Subject: AUDIO PANEL EDGES ARE WRINKLED / PEELING	Bulletin No: 09-026/16
	Last Issued: 04/25/2016

APPLICABLE MODEL(S)/VINS

2016 CX-5 vehicles with VINs lower than JM3KE*****779769 (produced before February 15, 2016)

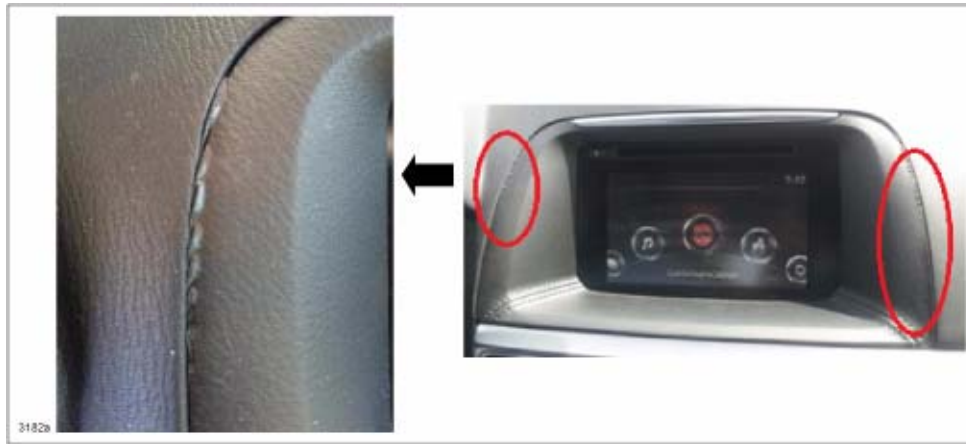
Some customers may notice that the audio panel (or center panel) is wrinkled or peeling at the edges, causing a poor appearance concern.

Protective tape has been added to the audio panel to eliminate this concern.

1. Verify the customer concern.
2. Replace the audio panel with a modified part according to the instructions on MS3 online or the Workshop Manual (section 09-17 CENTER PANEL REMOVAL/INSTALLATION).
3. Verify the repair.
